**Subject :** Diversion of 0.1739 ha. of forest land in favour of Commandant Home Guards 7<sup>th</sup> Battalion Kullu for the construction of Home Guards 7/4 Company Office Banjar/Fire Post at Banjar within the jurisdiction of Seraj Forest Division, Distt. Kullu, H.P.

Deputy Inspector General of Forests (Central) vide office online letter received from on dated 01-01-2024 On the subject cited above, it is submitted that to the point-wise reply to the shortcomings is furnished as under:-

**GEOLOGICAL STABILITY REPORT OF LAND IDENTIFIED**  
**FOR THE CONSTRUCTION OF BUILDING FOR THE FIRE OFFICE AT BANJAR**

## Lithostratigraphic classification of Rampur Group (Modified after Sharma, 1977)

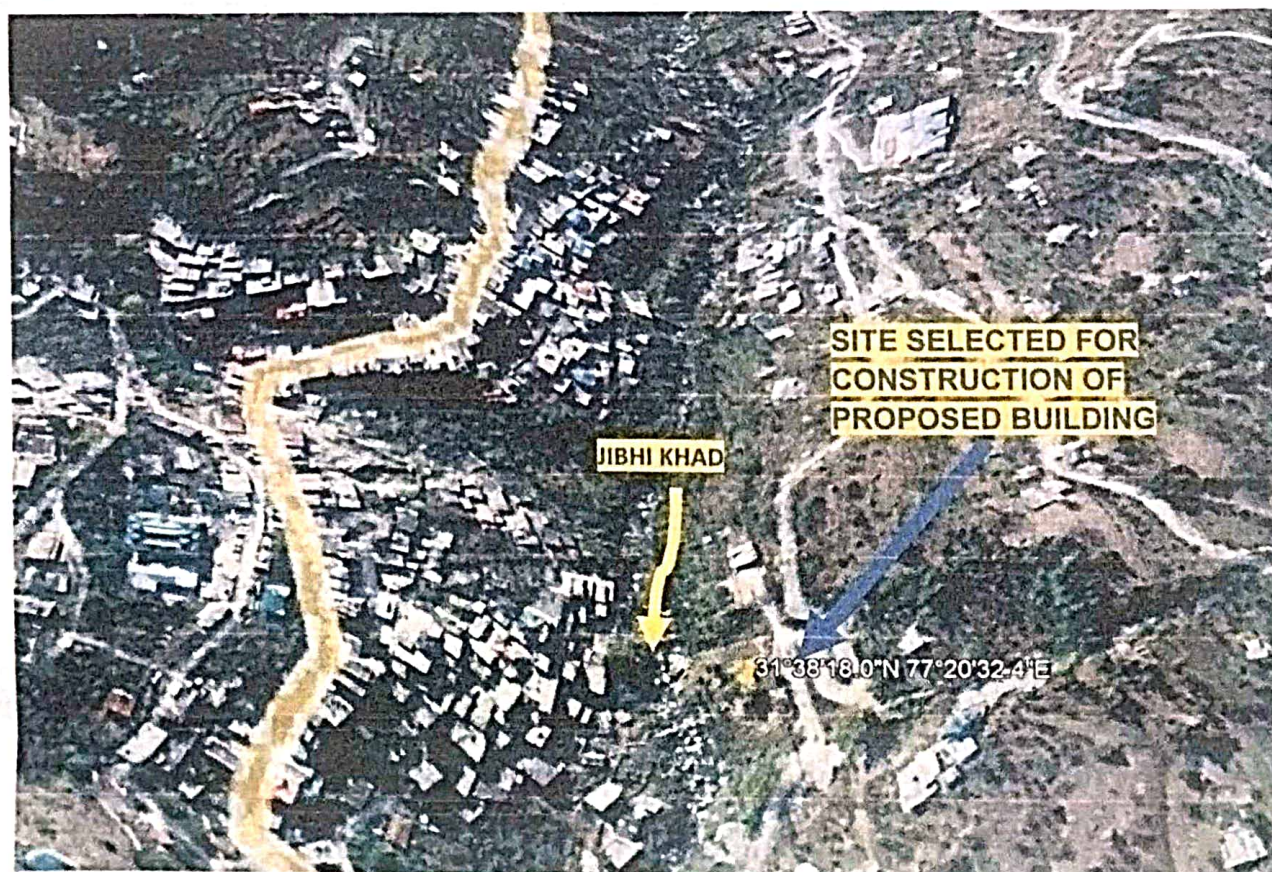
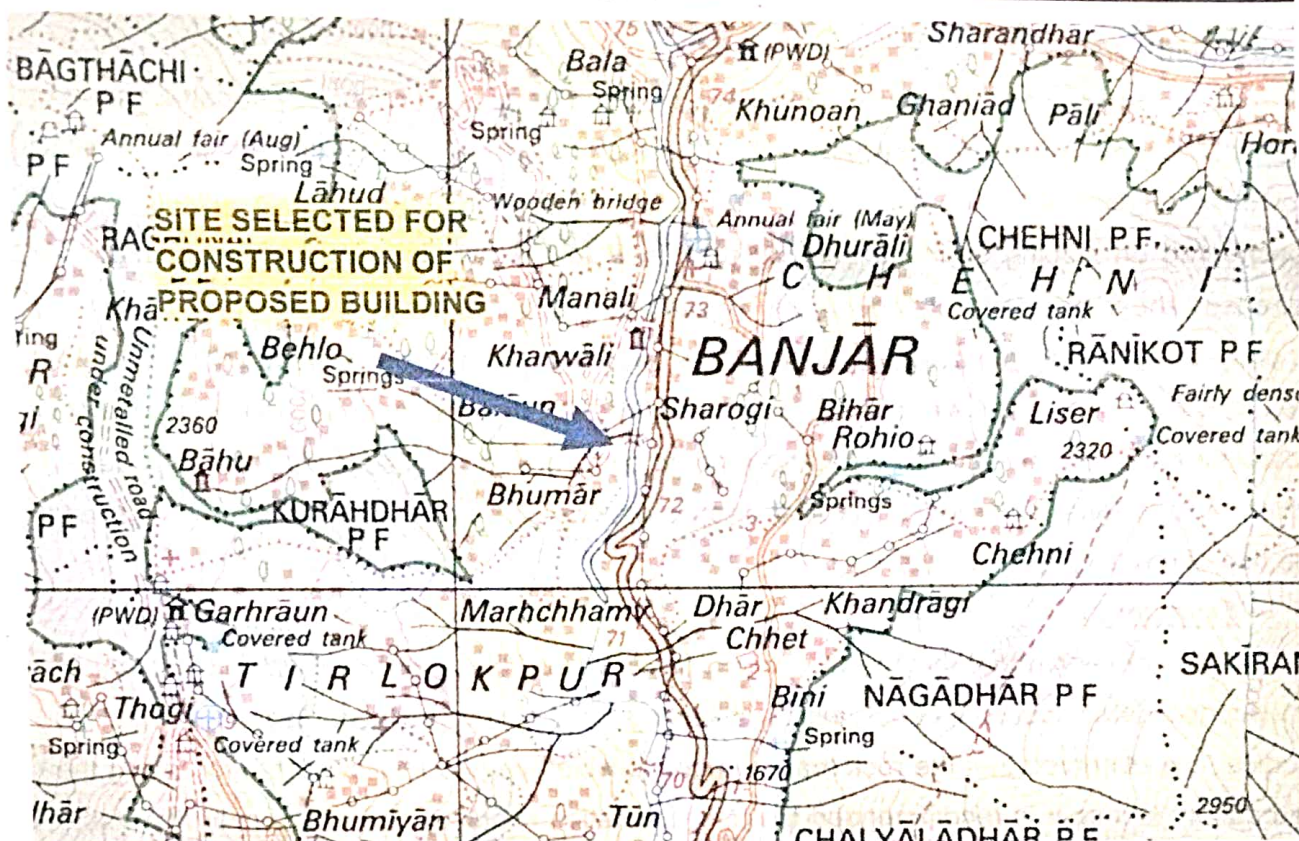
After the inspection of the proposed site, the following observations have been taken in consideration:-

2. The terrain of the site is largely sloping having an angle of 40-45 degrees with moderate slopes towards the downhill side and covered with the unconsolidated slope wash as well as road-cutting dumped material. The said area where muck has been dumped projects a sloping topography and the precise depth of rock can be obtained only after subsurface investigation of the area.

3. A perennial water channel i.e. Jibhi Khad has about 80 sq.km of catchment area flowing downhill side of the said chunk of land. The area is prone to moderate to heavy rainfalls which could result in flash floods and debris flow from the uphill side due to its peculiar geomorphic and Geological conditions in the Jibhi Khad catchment area. It is expected that during heavy rains the excessive water flow in the Khad could directly hit the toe portion and there may be a chance of toe erosion along the said land and there is a chance of landslide hence, the site needs to be protected before the construction of the Buildings.

In order to carry out construction activities, the hill slope needs to be stabilized. The uphill as well as valley side strata are covered with overburdened material and no insitu rock mass is encountered/ observed, So the following recommendations/ suggestions may be considered, which include removal of loose material, proper drainage, both surface and sub-surface and the use of restraining structures.

It was observed that the ground surface below this portion is covered with a thick mantle of unconsolidated loose material, which is resting on the rock surface. Based on the field studies, it is observed that the rock mass is not available over the shallow depth for laying the foundation, Hence it is recommended that the foundation should be laid deep over the stable rock mass, however, if the rock mass is not available at desired depth the foundation and building structure should be designed properly as per the topography and soil stability of the area.

As already mentioned a perennial water channel i.e. Jibhi Khad flowing downhill side of the said chunk of land has a large catchment area. During the rainy season there is always a chance of flash floods in the said Kahd hence the down hillside area of the said land needs to be protected in a suitable manner. A suitable protection work in the shape of Reinforce cement concrete retaining (RCC) from the upstream side should be erected along the water channel. The retaining walls constructed along the river channel must have deep foundations in order to minimize the chance of toe erosion. Weep holes should be provided along the retaining wall in order to allow the free drainage of underground water.
